# 68060 ERRATA

Rev 4.0 - 10/18/96

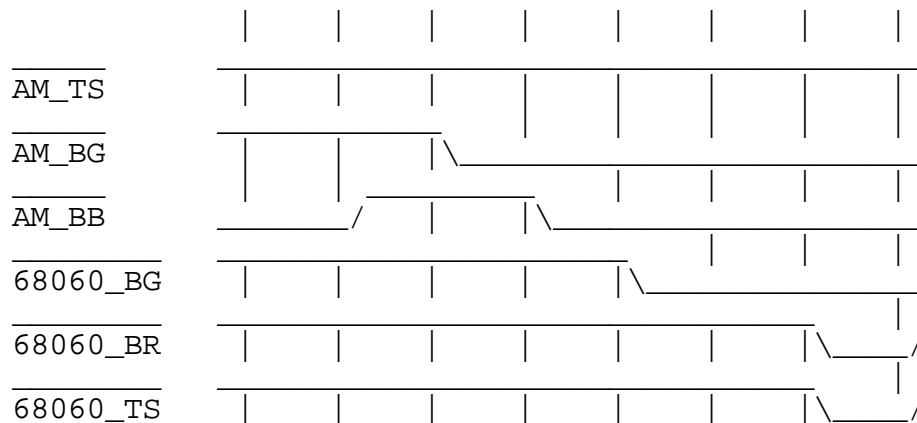
H4 - In systems with at least one alternate master which asserts only BB and not TS during bus tenure the 68060 may incorrectly take over bus mastership. This occurs if BG is asserted to both the alternate master and 060 where the alternate master had, at some time in the past, used the bus, relinquished the bus and started to use the bus again with no intervening bus cycles that assert TS. In this case, the 060 may run bus cycles if an internal request is pending without waiting for the alternate master to finish using the bus and negate BB.

The following timing diagram will illustrate this case.

Workarounds include:

Have the alternate master assert TS when it starts bus cycles

--OR--

Assure that the bus grants to an alternate master and 68060 are mutually exclusive

--OR--

Do not assert BG to the 68060 until the alternate master is done using the bus.
